HOPE CREEK GENERATING STATION
DOCKET NO. 50-354
DRAFT SAFETY EVALUATION REPORT
OPEN ITEM STATUS

Attachment 1 is a current list which provides a status of the open items identified in Section 1.7 of the Draft Safety Evaluation Report (SER). Items identified as "complete" are those for which PSE&G has provided responses and no confirmation of status has been received from the staff. We will consider these items closed unless notified otherwise. In order to permit timely resolution of items identified as "complete" which may not be resolved to the staff's satisfaction, please provide a specific description of the issue which remains to be resolved.

Enclosed for your review and approval (see Attachment 4) are the resolutions to the Draft SER open items listed in Attachment 3.

HOPE CREEK
GENERATING STATION
FINAL SAFETY ANALYSIS REPORT
PENETRATION CONDUCTOR
OVERCURRENT PROTECTION
FIGURE 430-48-1
SHEET 12 OF 21
AMENDMENT

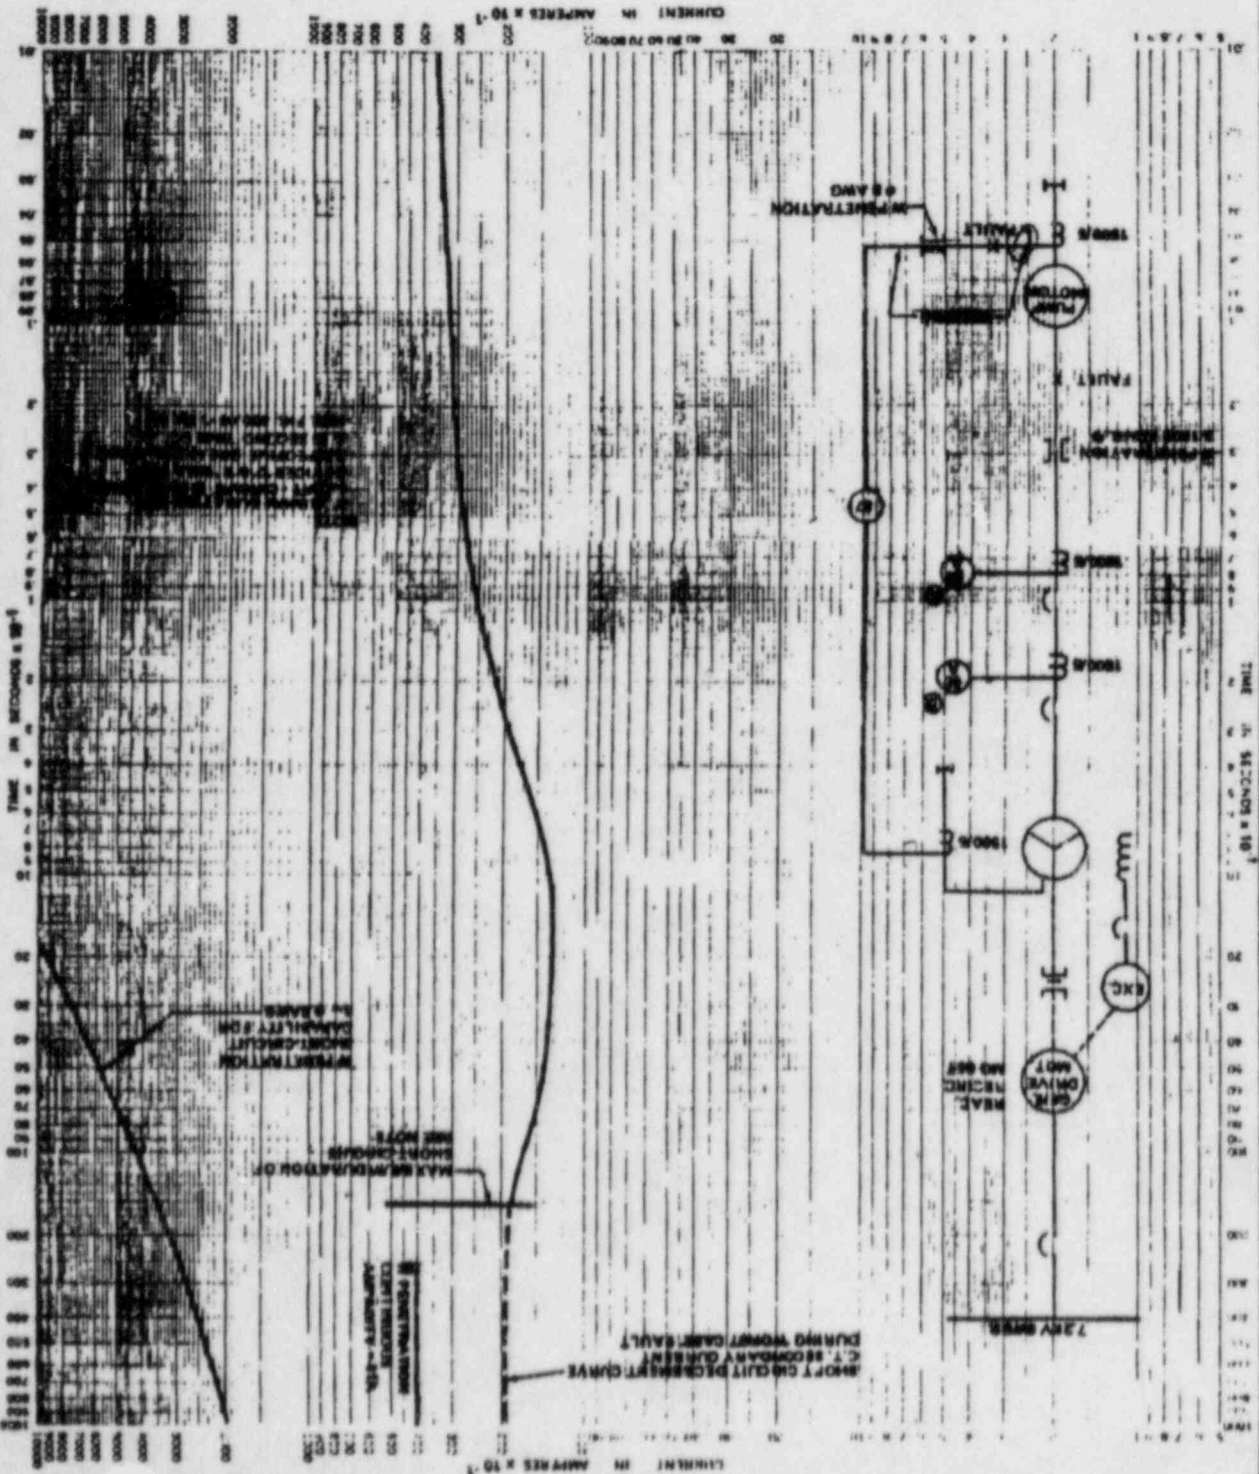
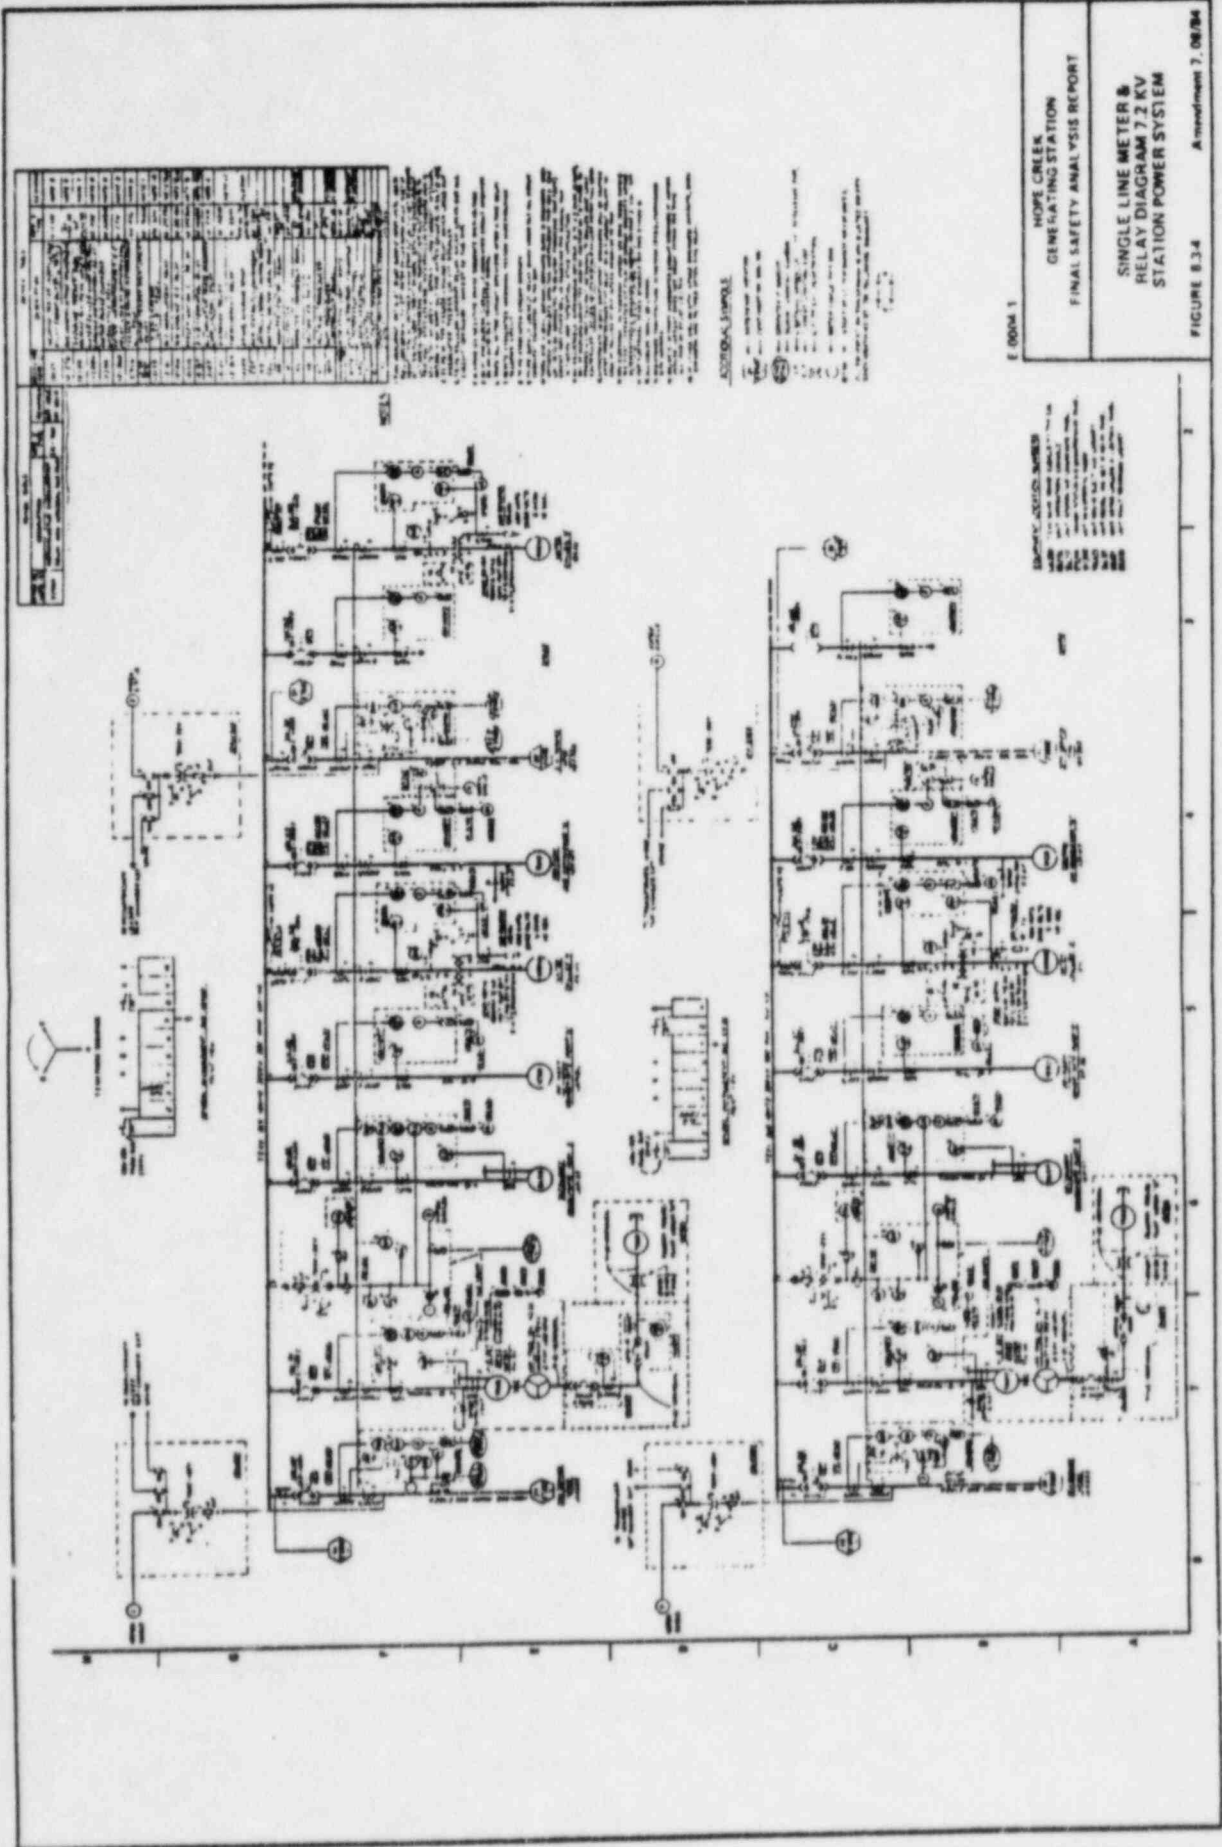
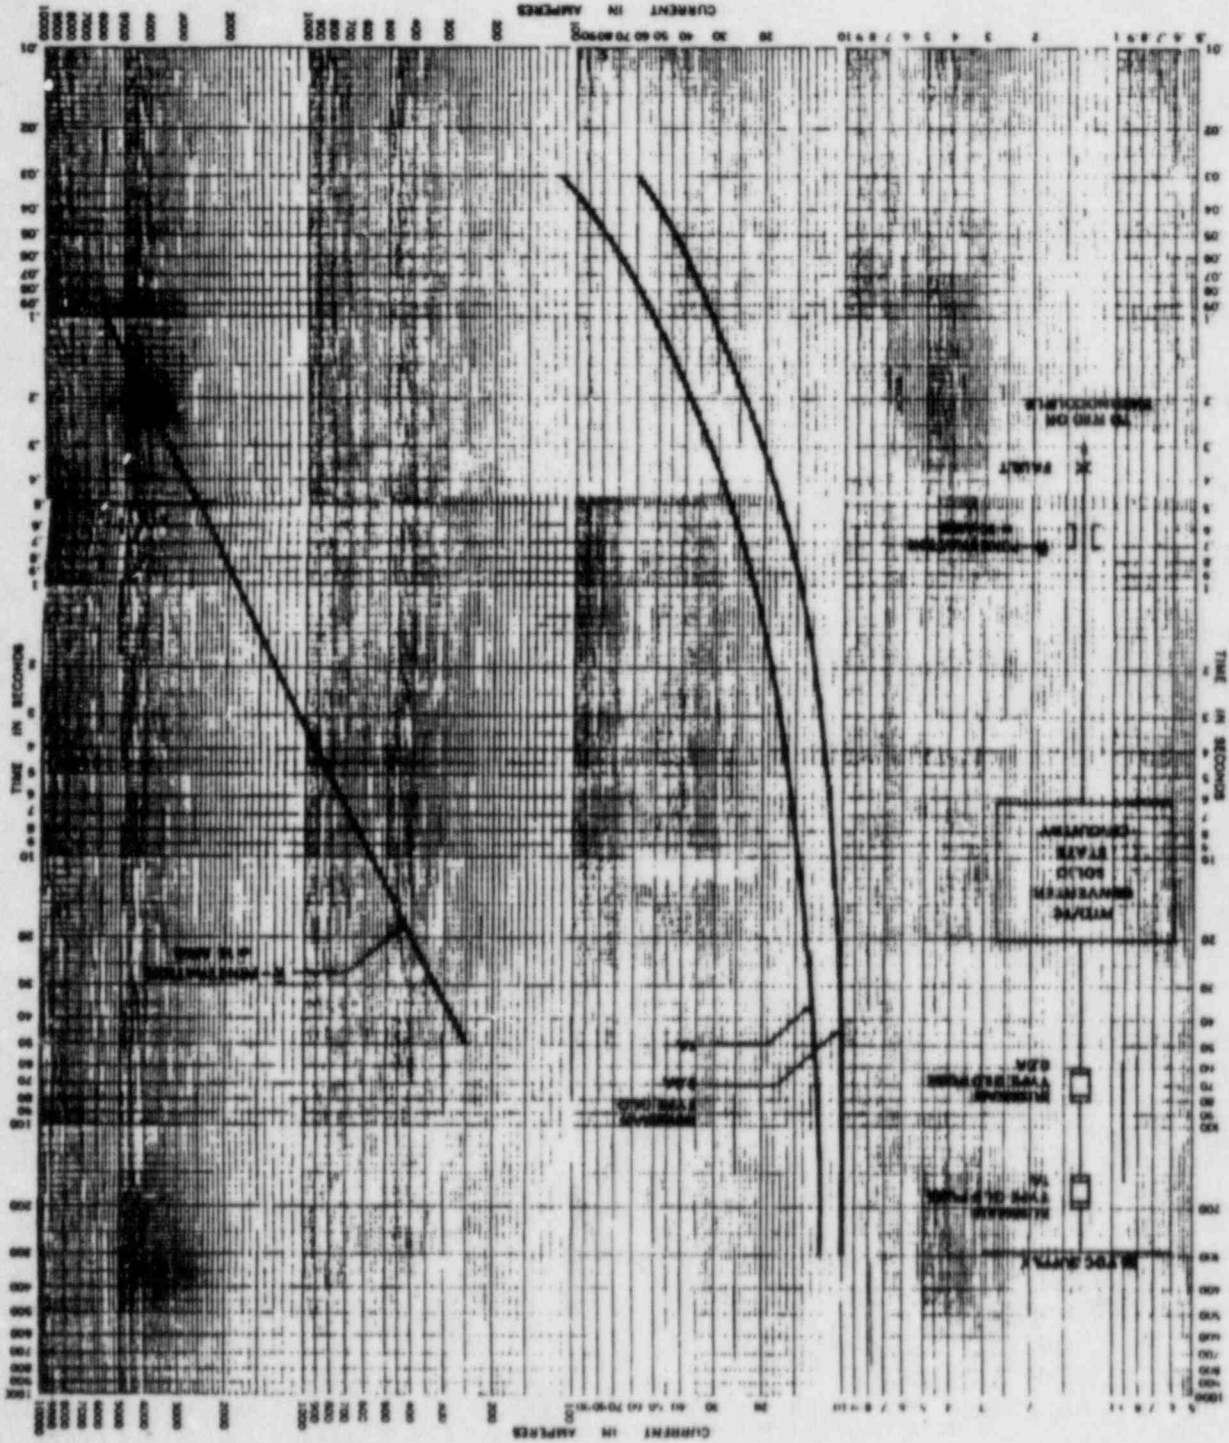
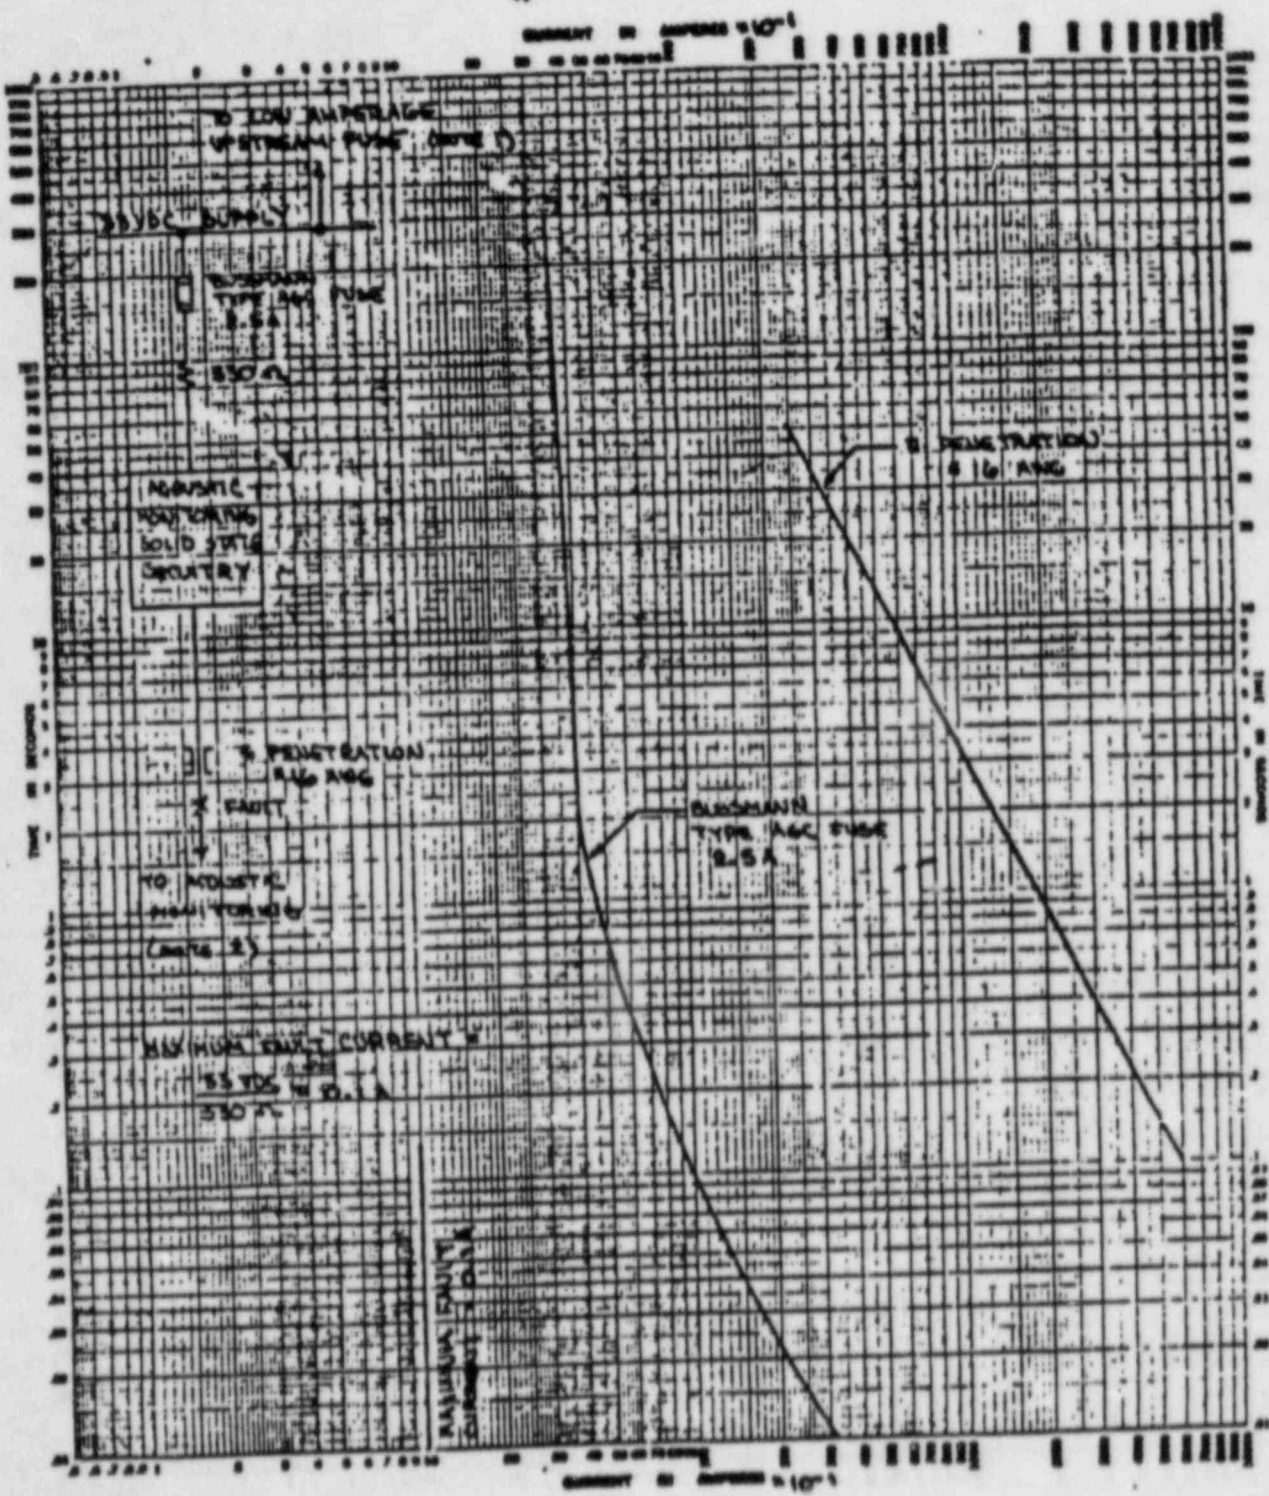
By Amendment 4 to the FSAR, the applicant indicated that coordinated fault-current versus time curves for representative penetration conductors and their protective devices are included in Figures 420.46-1 of the FSAR. Based on a review of these figures, the staff concludes that representative curves for motor differential relay, current transformer, and instrumentation circuits were not included in Figure 430.46-1. Inclusion of these circuits as well as other circuits such that the coordinated fault-current versus time curves is representative of all penetration circuits will be pursued with the applicant.

- a. Provide justification for noncompliance with the guidelines of position 1 of Regulatory Guide 1.63.
- b. Provide coordinated fault-current versus time curves for each representative type cable that penetrates primary containment. For each cable, the curves must show the relationship of the fault carrying capability between the electric penetrations, the primary overcurrent protective device, and the backup overcurrent protective device.
- c. Provide the test report with results that substantiates the capability of the electrical penetration to withstand the total range of time versus fault current without seal failure for worst case environmental conditions.

DSEI ITEM
251

RESPONSE

FSAR Section 8.1.4.12 has been revised in response to Question 430.46, and to address this concern.

FSAR Section 8.1.4.12 has been revised to provide the requested information.

HOPE CREEK
GENERATING STATION
FINAL SAFETY ANALYSIS REPORT
PENETRATION CONDUCTOR
OVERCURRENT PROTECTION
FIGURE 430.44-1
SHEET 11 OF 21
AMENDMENT 2

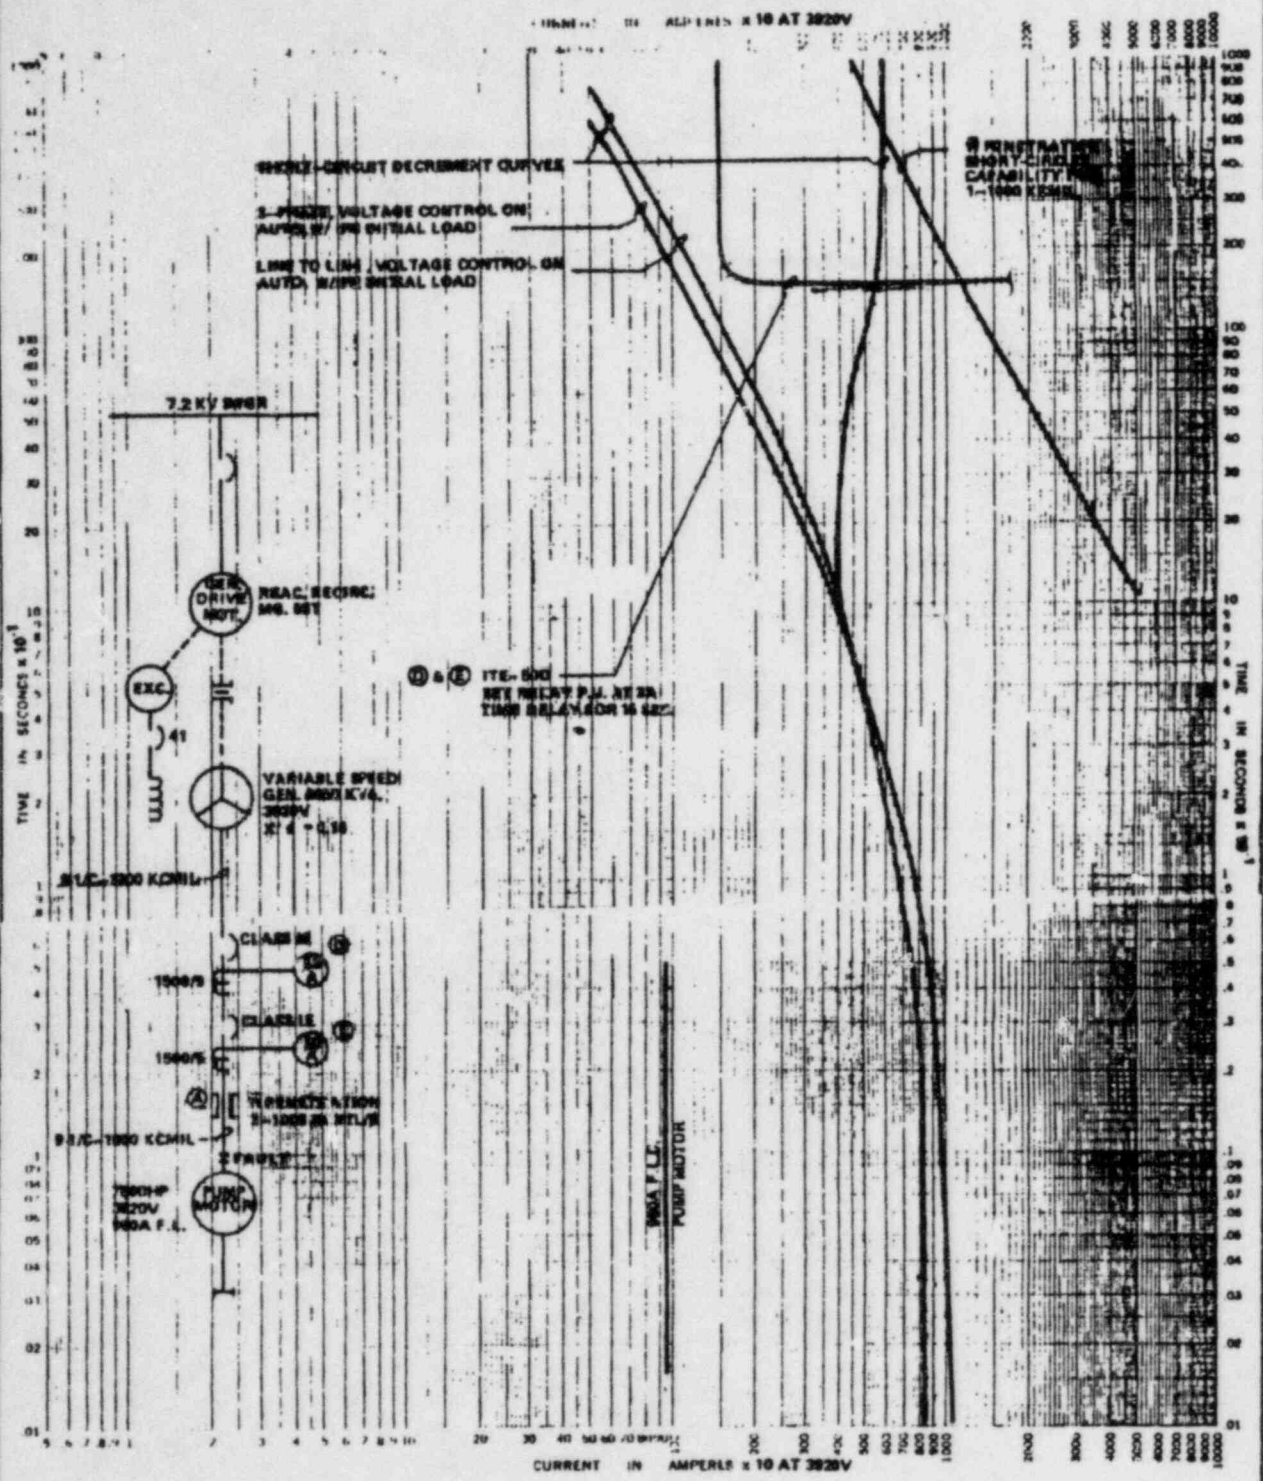
THE USE OF A SINGLE BREAKER TO PROVIDE PENETRATION PROTECTION

Figure 8.3-17, Sheet 11, has been provided to show two breakers.

The above cases illustrate that the intent of Reg. Guide 1.63 is met. No single failure of a circuit overcurrent protective device could cause a penetration failure. Refer to the representative curves of Figure 8.3-17.
